CONWAY HISTORIC DISTRICT COMMISSION MEETING

SEPTEMBER 25 , 2017 • 5:30PM • CITY HALL • 1201 OAK STREET

**ROBINSON HISTORIC DISTRICT
CERTIFICATE OF APPROPRIATENESS REVIEW
CLARK RENOVATION & REMODEL + DEMOLITION
1517 CALDWELL STREET**

Building Elevations

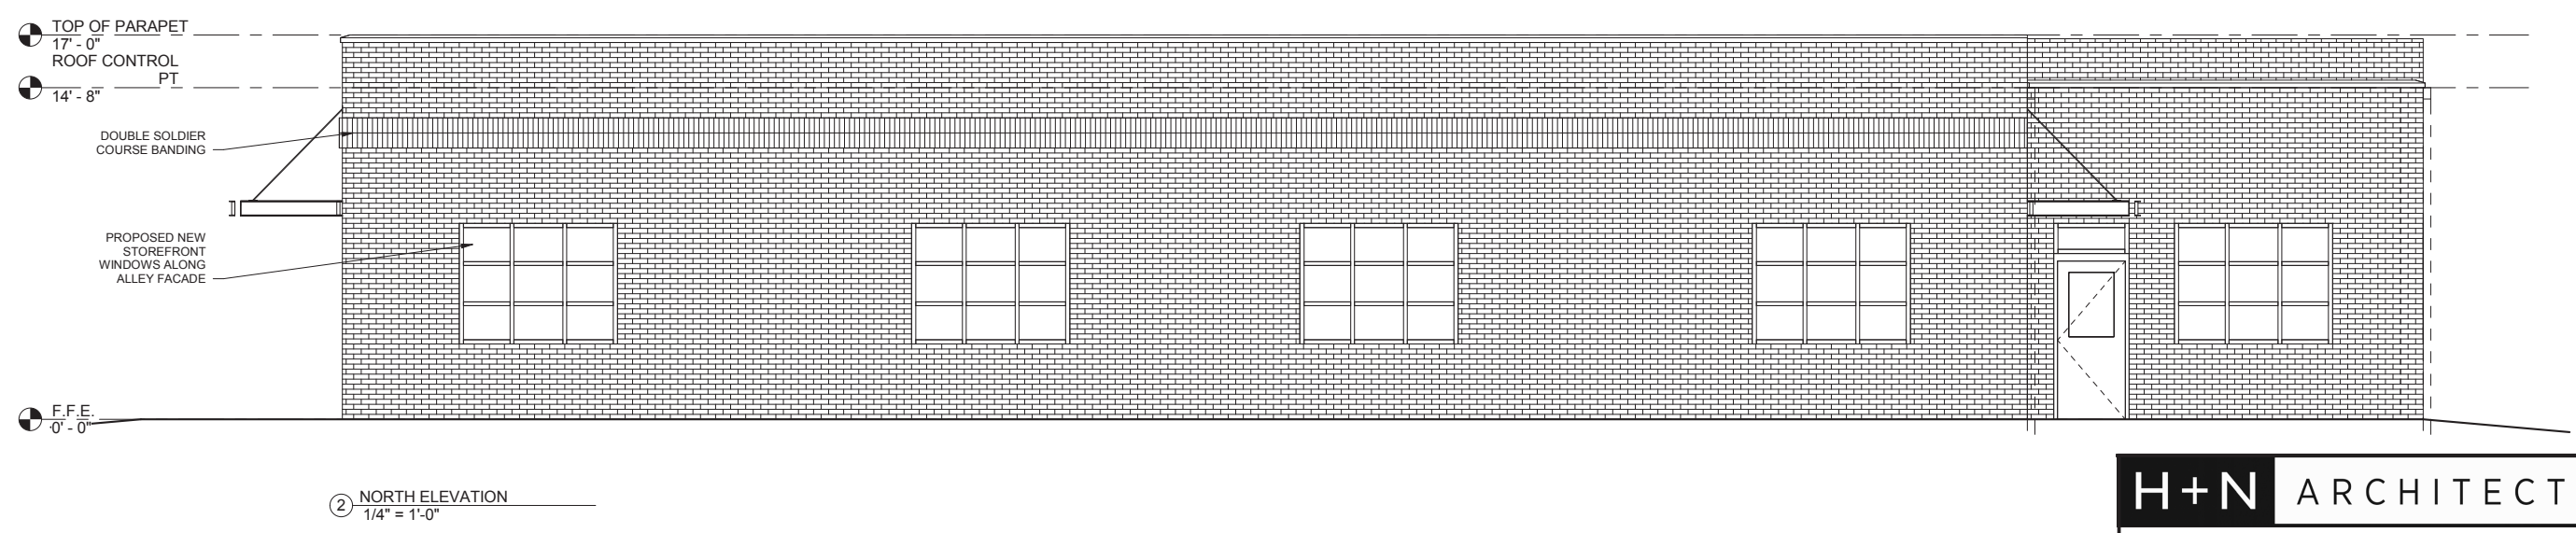
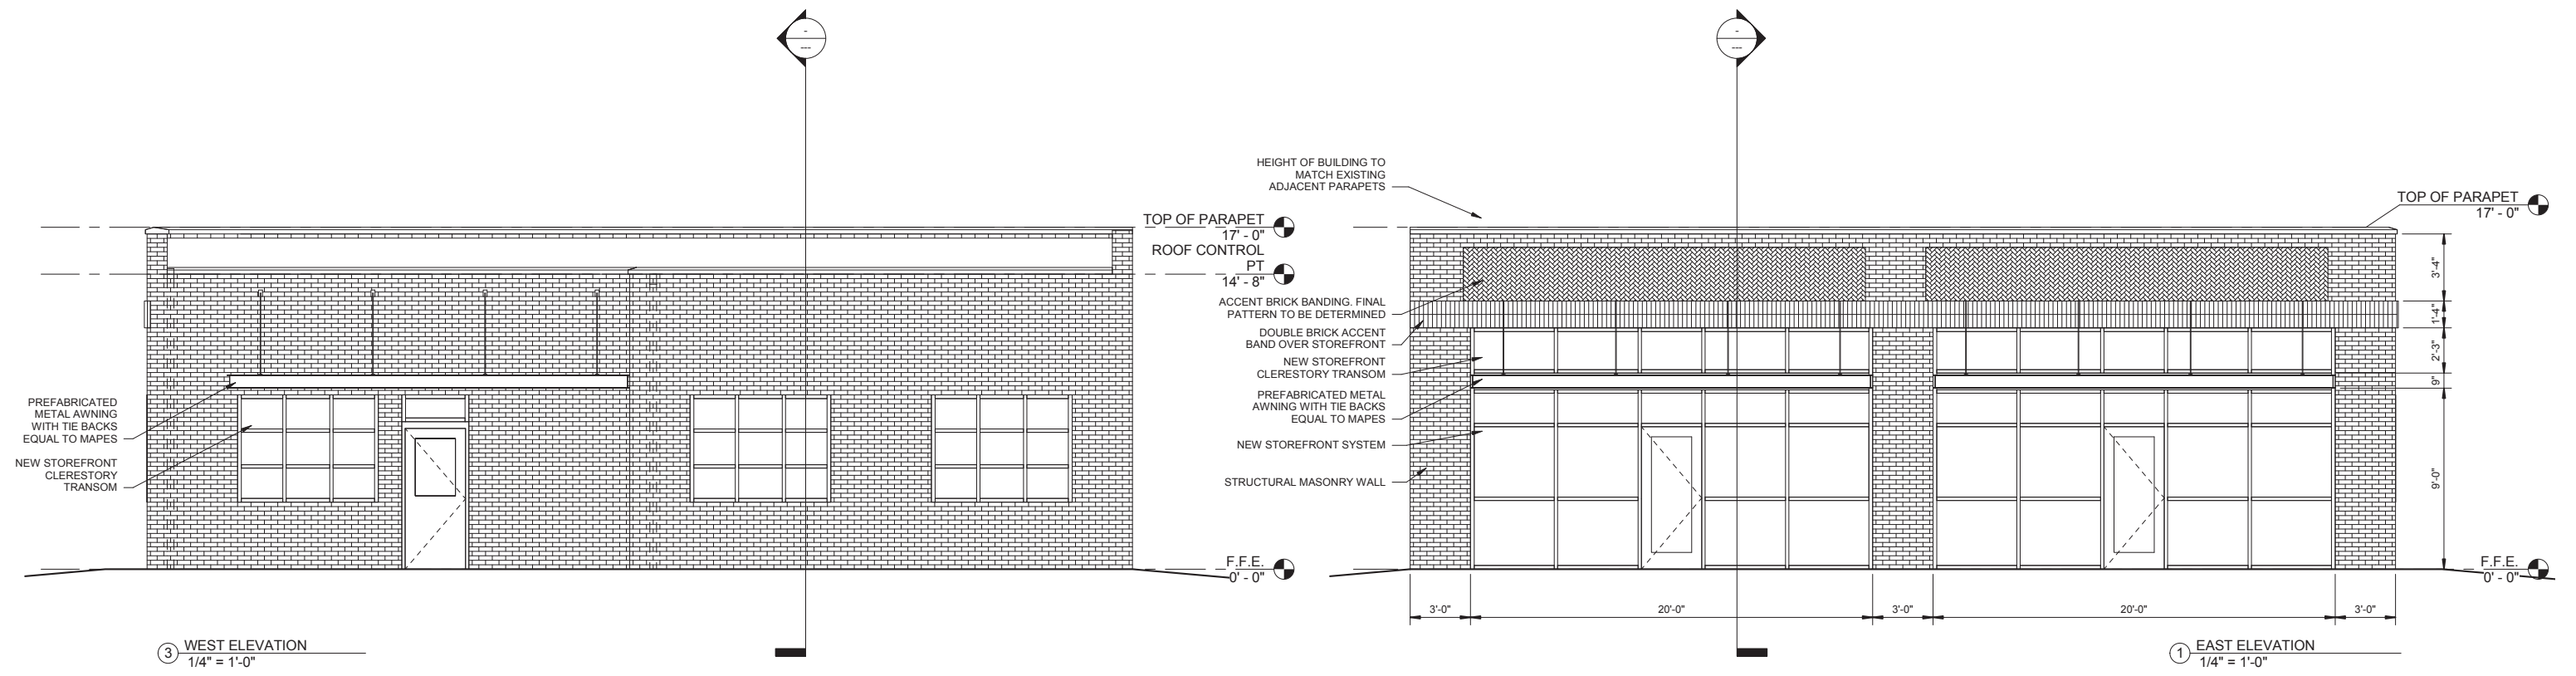
Height. The average height of area structure’s eaves and cornices. Also, the first floor elevation / height relationship. The 17 foot overall height matches abutting structures. The ceiling height of 12 feet is appropriate and meets the minimum 12 foot urban commercial building floor to ceiling height requirement.

Width. New construction proportions shall respect the average widths of the majority of neighboring buildings in the area. The width of the structure with 2 commercial bays matches abutting commercial structure widths.

Complexity of form. The level of detailing and breaks in wall planes of a structure. The new building has glass storefronts, awnings, glass transoms, accent panels, and varying brick courses. This level of complexity creates interest and is appropriate for a traditional commercial building.

Doors and windows. The rhythm, patterns, and ratio of voids to solids of new buildings should relate to and be compatible with adjacent facades; typically a higher proportion of voids to wall area. The new building has typical storefront glass and doors. Large commercial windows will be added to the north (side) and west (rear) elevations.

Awnings. When new construction uses awnings, traditional awning designs, materials, and placement should be used. Awnings are shown over the front glass storefronts. The awnings are traditional in form and appropriately do not extend across the brick pilasters. By not extending across the pilasters, the rhythm set up by the glazing and pilasters is not interrupted.

Architectural Details, Siding, and Bricks. Eaves, brackets, dentils, cornices, molding, columns, trim, etc. The overall siding material is brick. Brick soldier coursing, accent panels are also used. Glass storefronts, awnings, glass transoms, etc. are used to provide an appropriate level of detailing for a traditional commercial storefront.

Staff recommends approval of the addition, open carport, and driveway with the following conditions:

1. The commercial structure shall be constructed as shown in submitted plans.

Building Elevations

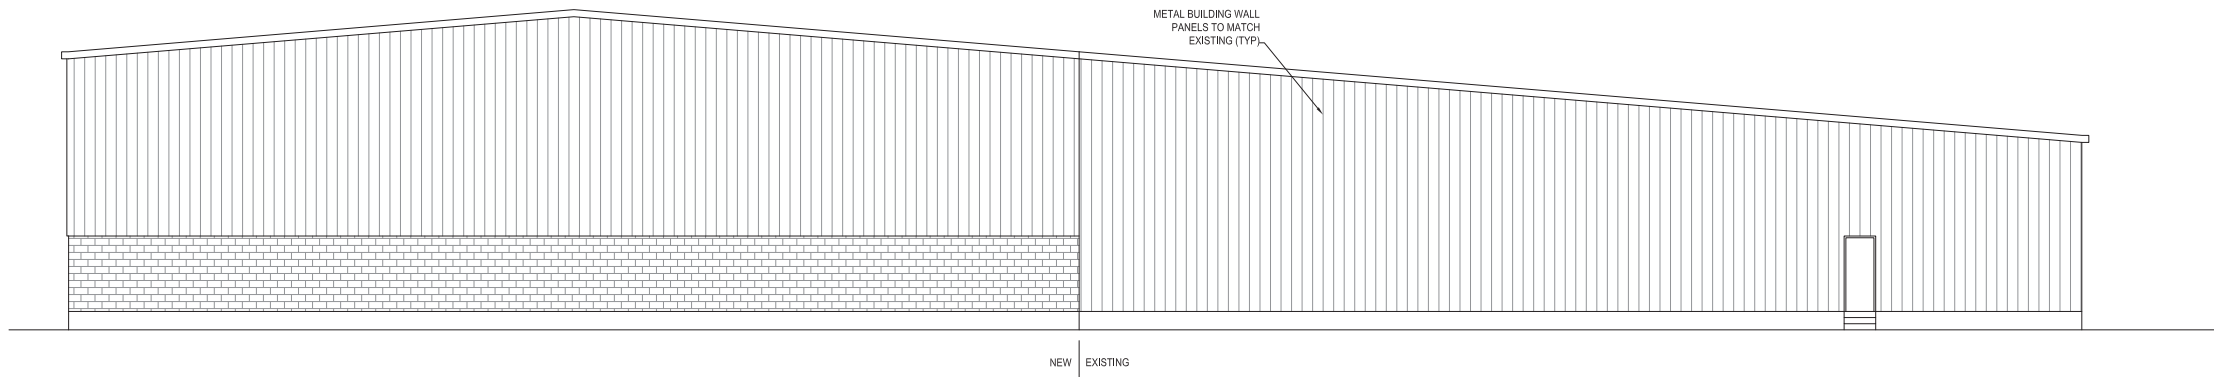
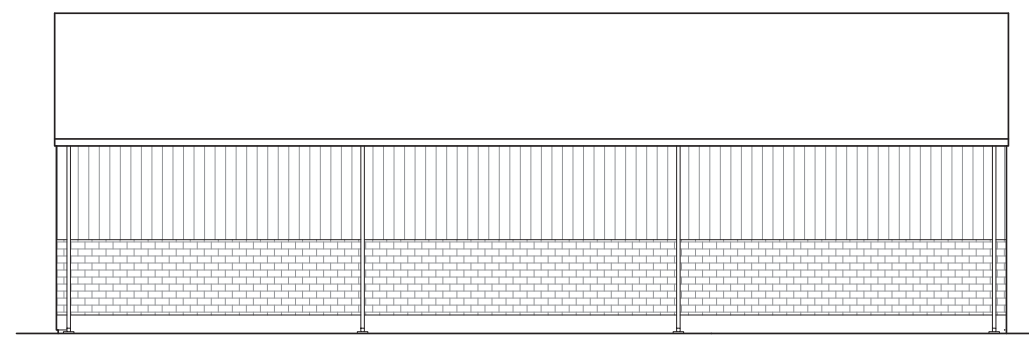
Height. The average height of area structure’s eaves and cornices. Also, the first floor elevation / height relationship. The new addition’s height will be a continuation of the existing structures roof line and pitch. The maximum height will be around 25 feet on the west end and 18 feet on the east side of the structure.

Facade, wall area, rhythm. Facades shall be compatible with surrounding historic structures in proportion of wall to opening area. The new addition is utilitarian in nature. It is an addition onto a large basic metal structure that predates the creation of the Old Conway Design Overlay District. The facade is basic in nature. The addition’s facade will match the old facade.

Doors and windows. The rhythm, patterns, and ratio of voids to solids of new buildings should relate to and be compatible with adjacent facades; typically a higher proportion of voids to wall area. The new addition will have 2 roll up commercial doors for loading and trash. Two entry doors will be provided; one between the two roll up doors on the south facade and one on the north facade.

Architectural Details, Siding, and Bricks. Eaves, brackets, dentils, cornices, molding, columns, trim, etc. The existing metal structure is largely void of any architectural detailing. The structure is a large metal warehouse building with a concrete block wainscot. The addition is shown with matching detailing.

All elevations include the masonry wainscot with the exception of the north elevation. The north elevation is completely hidden from view behind the shopping center to the north.

Staff recommends approval of the warehouse addition, parking, and loading area with the following conditions:

1. The warehouse addition, parking, and loading area shall be constructed as shown in submitted plans.
2. Landscaping including understory trees along First Street, shall meet zoning ordinance development review regulations.
3. Zoning ordinance development review regulations shall address lighting, dumpster pen size and materials, parking, etc.
4. A 5 foot sidewalk is required along First Street or an in-lieu fee of \$2025 must be paid. The sidewalk location should be coordinated with City Planning, Engineering, and Permits Departments.

Site Plan

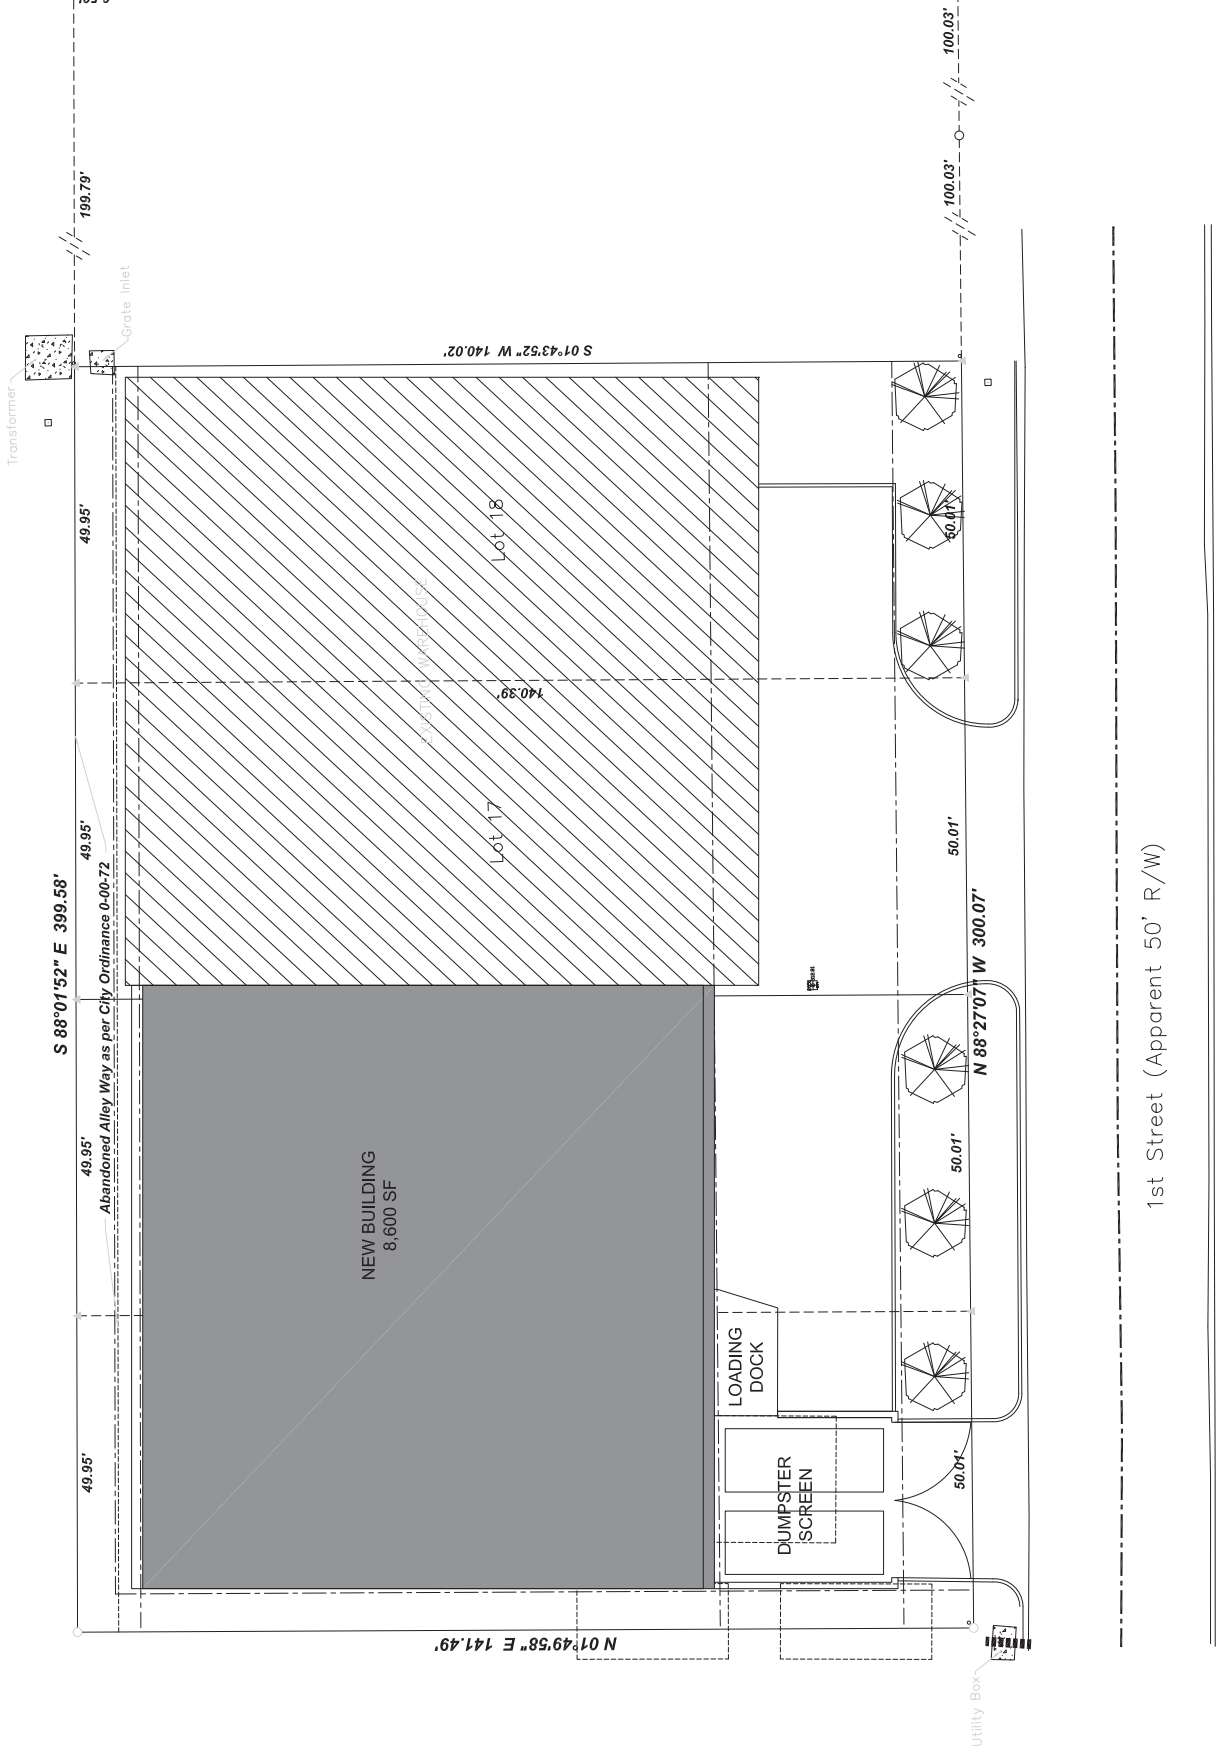
Driveway / Parking. The property is currently served by a continuous curb cut and a large gravel parking area. The proposed plan shows a new paved parking area with landscaping. There is also a dumpster pen area served with an additional curb cut.

Sidewalks. There is no sidewalk along First Street. A sidewalk must be constructed along the 135 feet of First Street frontage (minus driveways) or an in-lieu fee of \$2025 must be paid. The HDC can approve or disapprove the use of an in-lieu fee. Fences. No fencing is proposed.

Tree preservation. No trees will be affected by the development. New trees are shown along First Street in the new improved landscaping area. There is overhead power. Understory trees should be planted in this area at a ratio of 1 understory tree per 15 feet per development review regulations.
